Pre-Development Conference Notes

Project Name: Sacajawea Middle School Replacement

Project Name: Sacajawea Middle School Replacement
Permit No.: B21M0054PDEV
Site Address: 401 E 33rd Ave
Parcel No.: 35322.0326
Meeting Date: Thursday, May 13, 2021

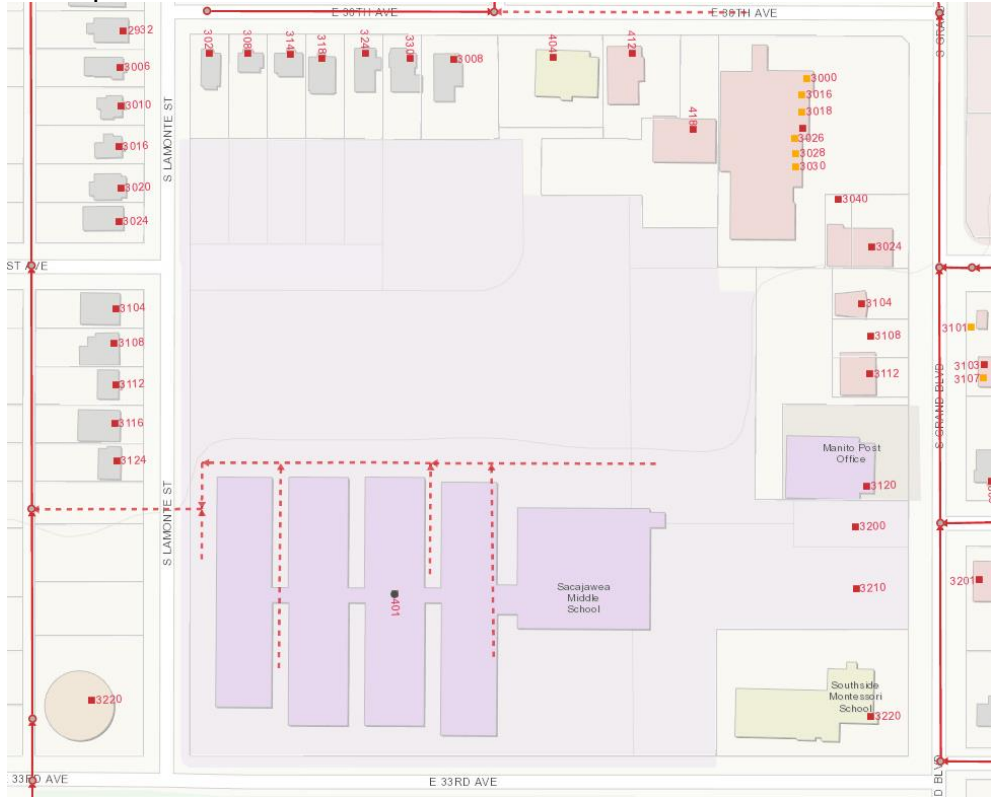
1. Our records indicate the existing school is served by a 1959 private sewer which connects to a public main in the alley between Manito Blvd and Lamonte St through an easement (unable to locate a copy of easement). The red dashed lines are the approximate location of the private sewer.

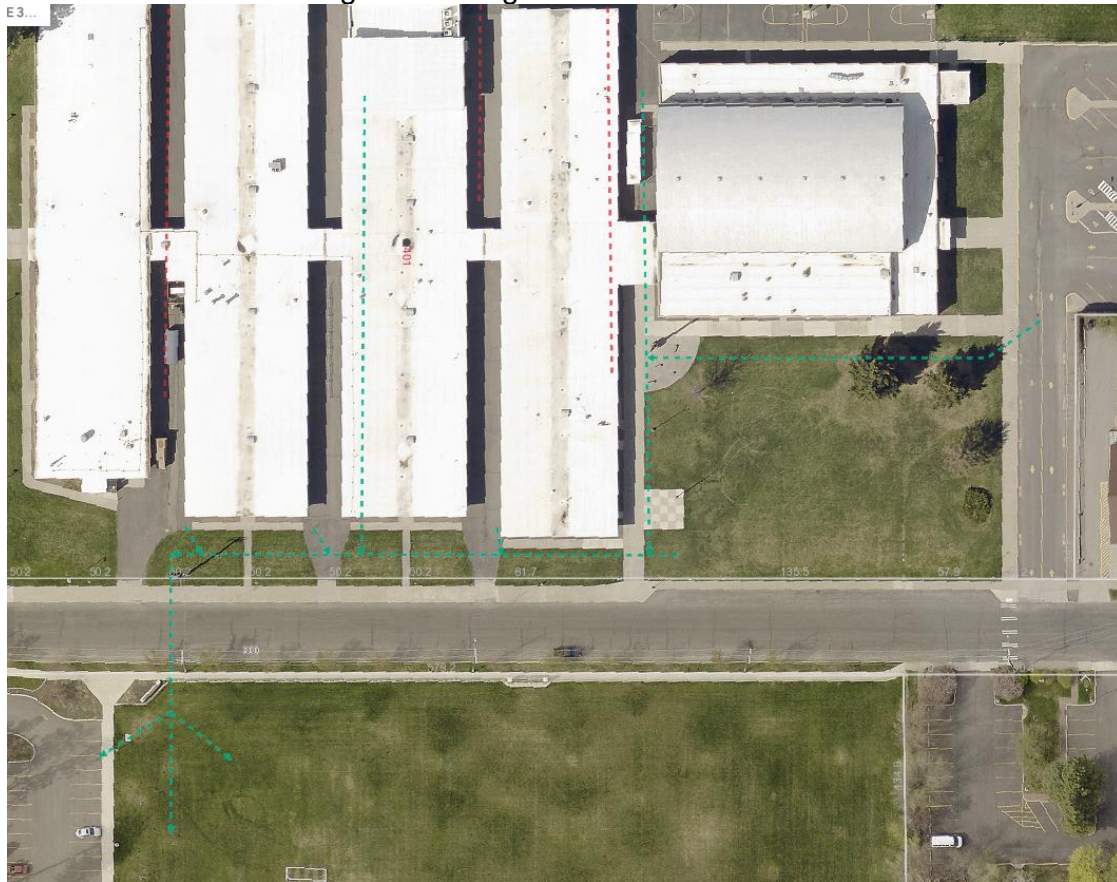
7. Our records show a private storm system that appears to collect runoff from the buildings and transports the stormwater across 33rd Ave to Hart Field. The dashed green lines below represent the approximate location of the private storm system. Since the school is being moved to the north, we recommend the private storm drain crossing public right of way be eliminated and all drainage be managed on-site.
